Work Order ID 115044

Item Name: Crosstube Assembly, Mid Aft

DART AEROSPACE LTD	Work Order:	115044
Description: Crosstube Assembly, Mid Aft	Part Number:	D206-667-247
Inspection Dwg: D206-667-247 Rev: A		Page 1 of 2

DRAWING NO. D206-667-247	TITLE CROSSTUBE ASS'Y (206L MID AFT)	REV. A	DART AEROSPACE LTD ENGINEERING ORDER		D.E.O. NO. D206-667-247-A-1	SHEET NO. SHEET 1 OF 1	SCALE NTS
DRAWN 97	CHECKED ASS	MFG. APPR. AB	APPROVED JMD		DE APPR. #		
DATE 11.07.15	DATE 11.07.20	DATE 11.07.21	DATE 11/07/21		DATE 11.07.21

DART AEROSPACE LTD HAWKESBURY, ONTARIO, CANADA	
DRAWING NO. D206-667-247	REV. A SHEET 1 OF 4
TITLE CROSSTUBE ASSY (206L MID AFT)	SCALE NTS

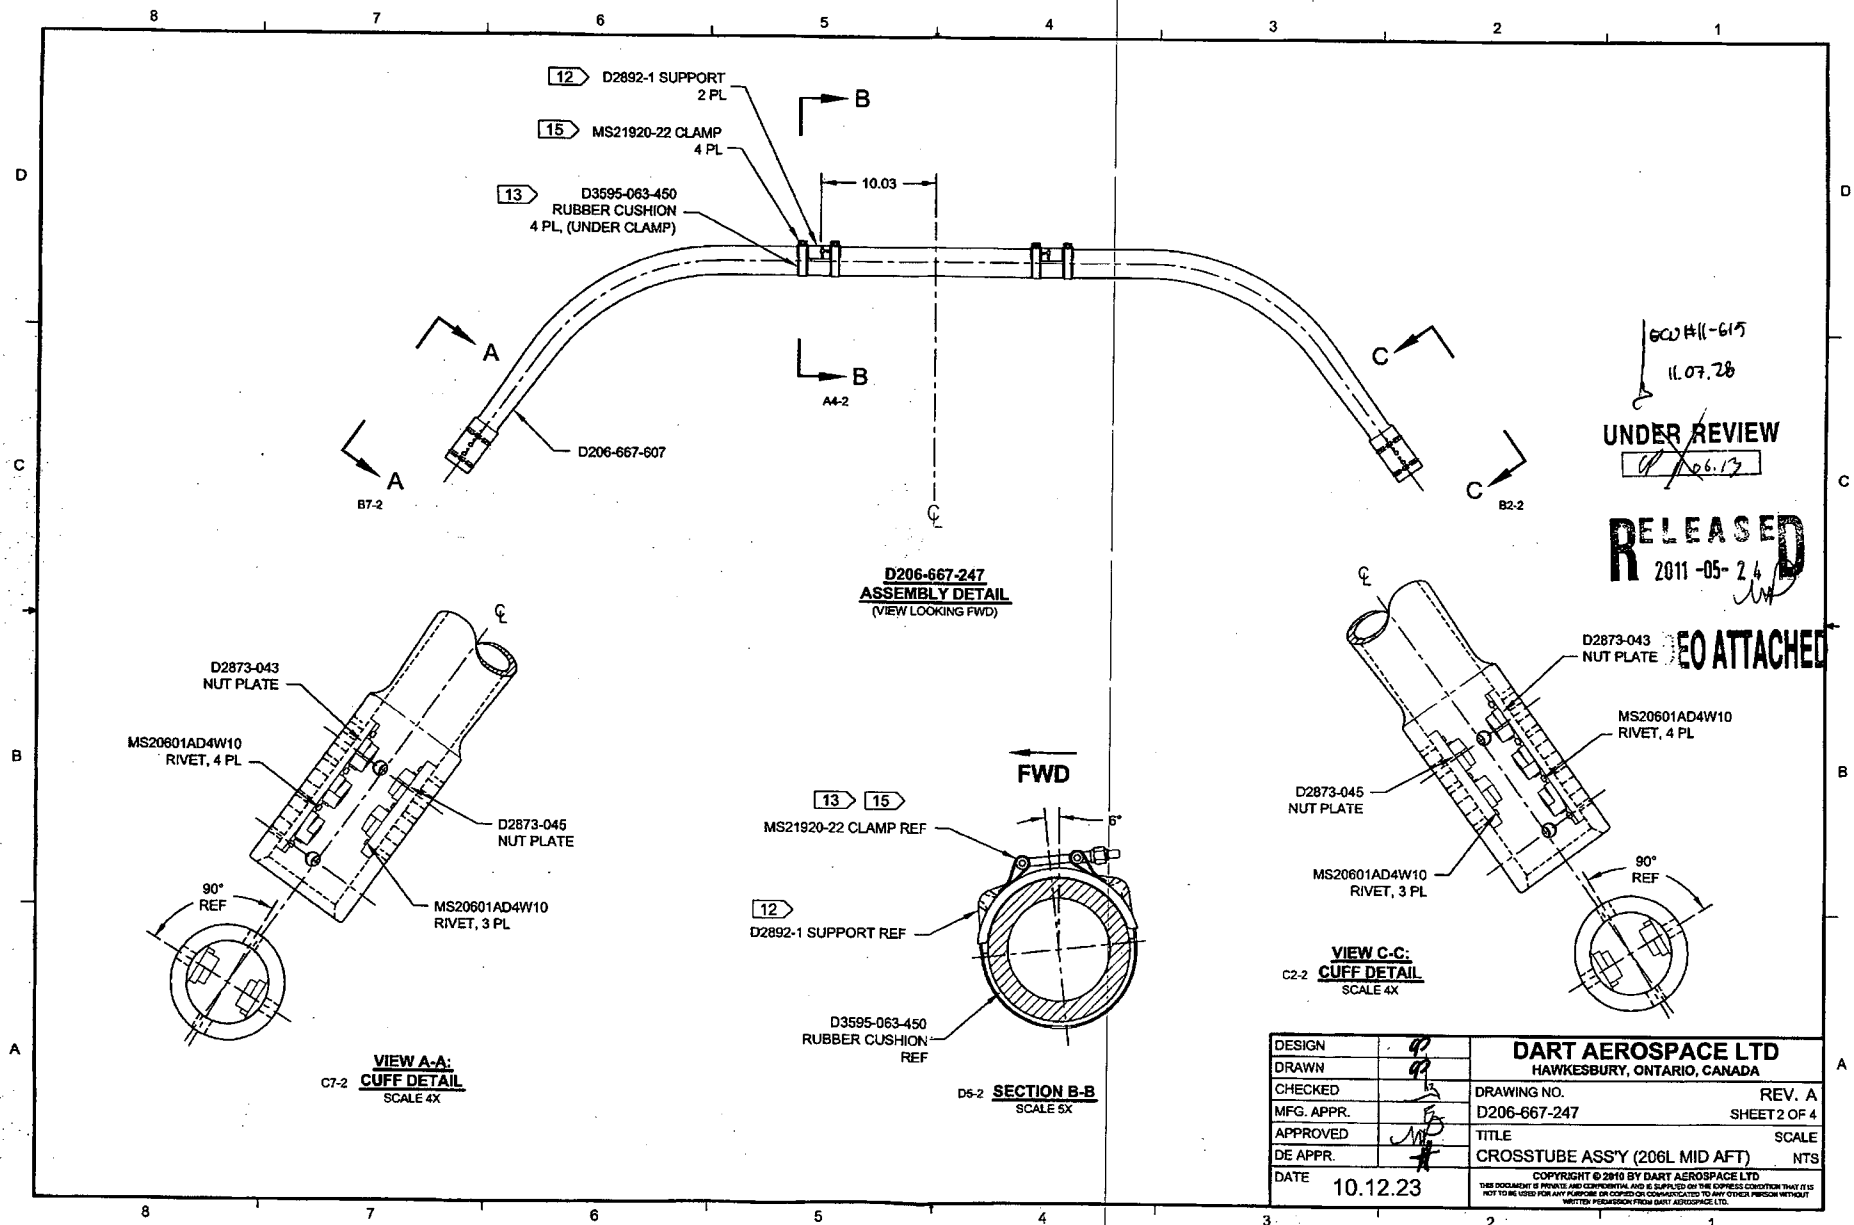
PURPOSE:

REPLACE MAGNOBOND WITH PROSEAL.

NOTE 12 & 15, SHEET 1 IS AMENDED AS FOLLOWS:

- 12) TO INSTALL D2892-1 SUPPORT: ABRASE MATING SURFACE OF SUPPORT AND CROSSTUBE WITH 180-GRIT SANDPAPER AND REMOVE RESIDUE WITH MEK (OR EQUIVALENT). APPLY A 0.04" TO 0.07" THICK LAYER OF PROSEAL 890 CLASS B-2 (OR AMS-S-8802 CLASS B-2) SEALANT TO MATING SURFACE OF SUPPORT.
- 15) TORQUE CLAMPS 80 TO 100 IN-LB. ENSURE AT LEAST 1.5 THREADS SHOWING IN SAFETY AND THAT NUT HAS NOT BOTTOMED-OUT AFTER TORQUING. **PRIOR TO PACKAGING, RE-CHECK TORQUE ON CLAMPS AFTER PROSEAL 890 SEALANT HAS CURED FOR 72 HOURS.**
